## **Additional SAS-1.1 Expander Issues**

**September 28, 2005**

## Issue 1: SAS Expander additional qualification in Arb Won

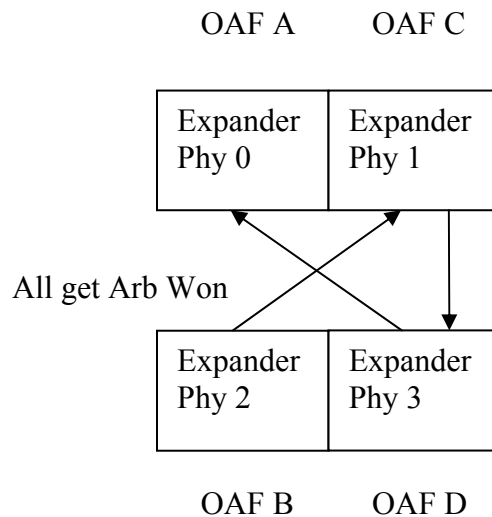
An additional qualification is necessary for an expander link to receive an Arb Won message from the expander function. Consider the following scenario.

Expander Phys 0, 1, 2, and 3 receive open address frames (OAF) A, C, B, and D respectively, where by arbitration rules  $D > C > B > A$ . Oaf A received on expander phy 0 requests a connection to expander phy 2, Oaf C received on expander phy 1 requests a connection to expander phy 3. OAF B is destined for expander phy 1 and OAF D is destined for expander phy 0.

Assuming there are sufficient routing resources and the connection rates are valid this scenario proves to be problematic. The expander function receives four request path messages from the respective expander phys. The value of phy status during this phase of the request path is such that Condition a) is satisfied for all ports. Condition b) is satisfied based on the assumption that the expander is designed accordingly. Condition c) rules out expander phy 0 to receive an Arb Won message since  $OAF D > A$ . Condition d) does not create any further restrictions since each OAF is destined to a unique expander phy.

Thus, since all conditions are met, an Arb Won message is issued to expander phy 3 with OAF D, expander phy 2 with OAF B, and expander phy 1 with OAF C. There are two error cases that need to be considered:

- 1) Expander phy 1 should not receive an Arb Won as it will cause a collision in the connection between expander phy 0 and 3
- 2) Expander phy 2 should not receive an Arb Won since OAF B sent to an end device attached to expander phy 1 will be ignored due to  $C > B$ . Further, expander phy 1 may have issued AIP due to receiving OAF C, which in turn could result in a hung connection attempt (i.e. an Open Timeout would not occur).

A recommendation to solve this problem is to add the following clause to the Arb Won qualification.

- e) the connection request of this expander phy is higher priority than an outstanding connection request of the destination expander phy.
